APPEAL SUMMARY

Appeal ID: 18797	Project Address: 2830 SE 71st Ave
Hearing Date: 12/19/18	Appellant Name: Mary Hogue
Case No.: B-006	Appellant Phone: 5034328588
Appeal Type: Building	Plans Examiner/Inspector: Preliminary
Project Type: residential	Stories: 2 Occupancy: R Construction Type: V-B
Building/Business Name: Pettigrew Residence	Fire Sprinklers: No
Appeal Involves: Alteration of an existing structure LUR or Permit Application No.:	
Plan Submitted Option: pdf [File 1]	Proposed use: residential

Appeal item 1

Code Section 2017 ORSC R311.7.2 Headroom

STAIR SECTION THRU UPPER LANDING LOOKING EAST

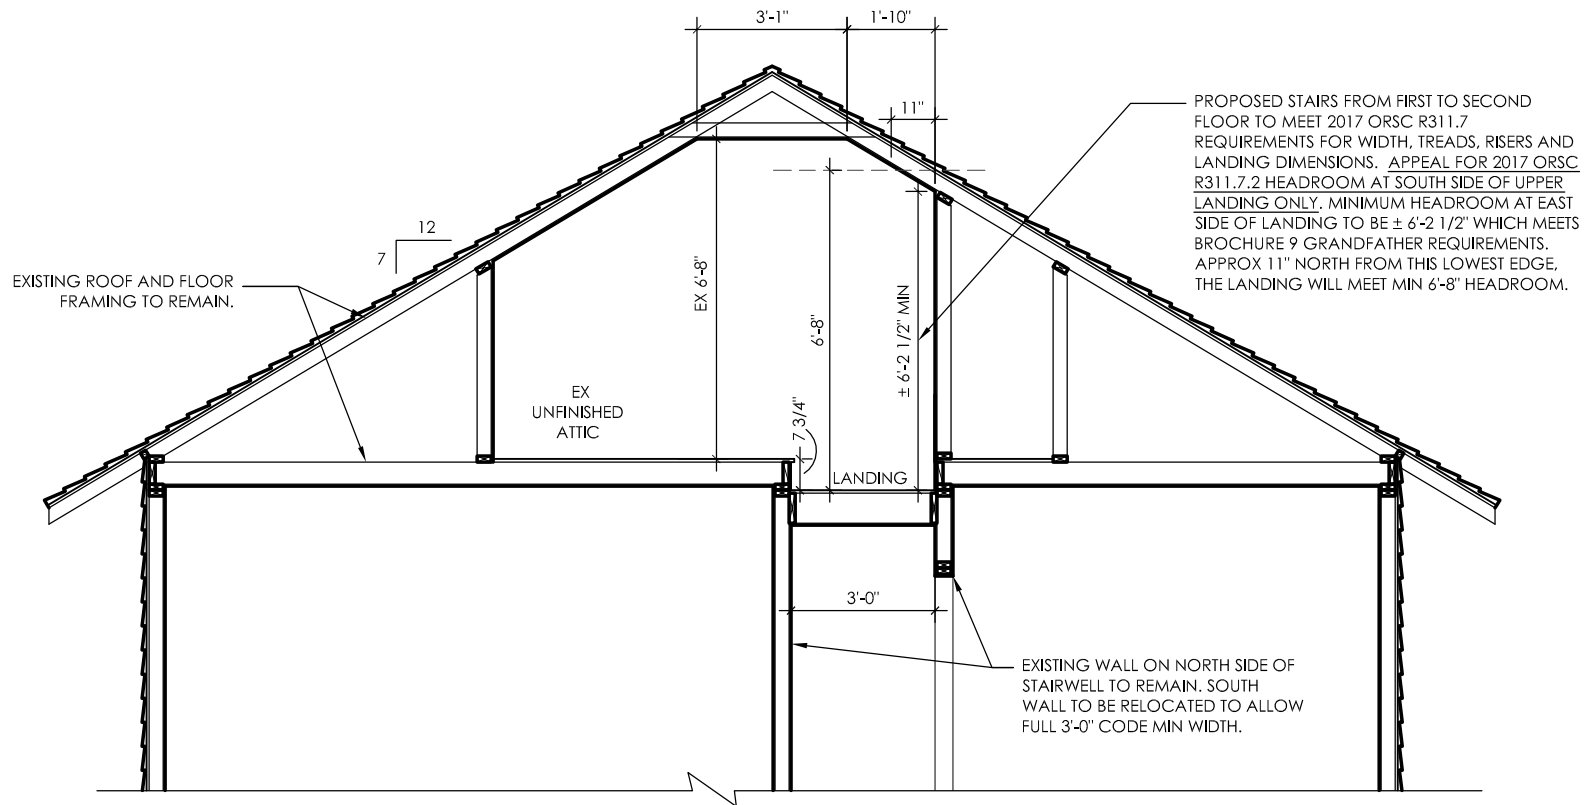
APPEAL FOR 2017 ORSC R311.7.2 MIN 6'-8" HEADROOM.

THE HEADROOM IN STAIRWAYS SHALL BE NOT LESS THAN 6 FEET 8 INCHES MEASURED VERTICALLY FROM THE SLOPED LINE ADJOINING THE TREAD NOSING OR FROM THE FLOOR SURFACE OF THE LANDING OR PLATFORM ON THAT PORTION OF THE STAIRWAY.

DUE TO THE EXISTING AVAILABLE HEIGHT OF THE UNFINISHED ATTIC, THE NEW STAIRS REQUIRE AN APPEAL FOR HEADROOM AT THE TOP OF THE SECOND FLIGHT ONLY. THE UPPER LANDING INTO THE ATTIC HAS MIN 6'-2 1/2" HEADROOM ALONG THE SOUTH EDGE. 11" NORTH OF THIS LOW HEADROOM EDGE, THE ROOF PITCH ALLOWS FULL 6'-8" HEADROOM.

ASIDE FROM THE REDUCED HEADROOM OF A PORTION OF THE UPPER LANDING, BOTH FLIGHTS OF THE PROPOSED STAIRS WILL MEET ALL 2017 ORSC R311.7 STAIRWAYS CODE REQUIREMENTS.

Reconstruction of 2nd floor stairs with reduction in minimum required headroom: Granted as proposed.
